## REMARKS/ARGUMENTS

## Amendments to the Drawings:

FIG.5

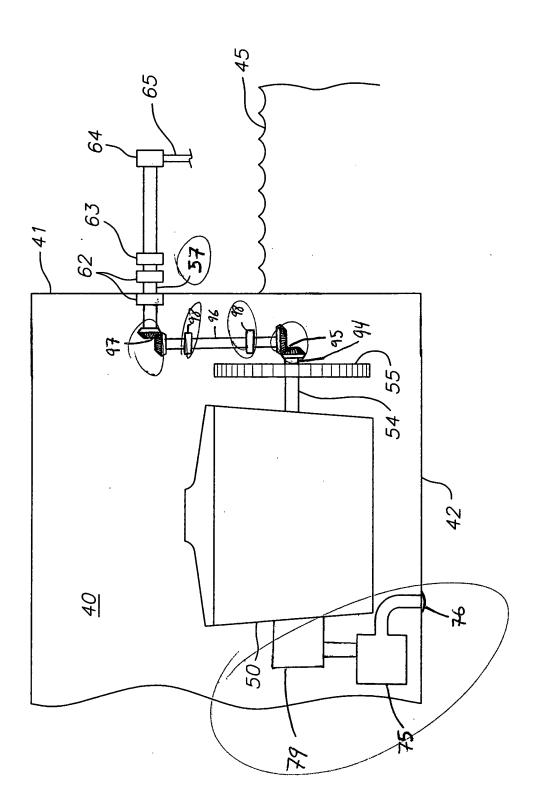
The Examiner has objected to the Drawings under 37 CFR 1.83(a), noting that the drawings must show every feature of the invention specified in the claims. Accordingly, Applicant has amended Fig. 5 to more clearly show the upper gear set 97 and lower gear set 95 as bevel gears. Support for these bevel gears may be found in the paragraph in the specification beginning on page 7, line 15.

Fig. 5 also now shows a water pump 75, water intake 76 and a cooling system 79 connected to the engine 50. Page 15, line 3 of the specification has been likewise amended to denote these elements in the context of Fig. 5. Support for these amendments to the Fig. 5 and the specification may be found on page 7, line 24, which recites:

In addition, Applicant has now added the two bearings 98 to Fig. 5, these having been inadvertently omitted from the previous Fig. 5 and support for which may be found on page 14, line 22, as well as having corrected notation for the upper driveshaft 57, which was inadvertently labeled "52" in the previous Fig. 5.
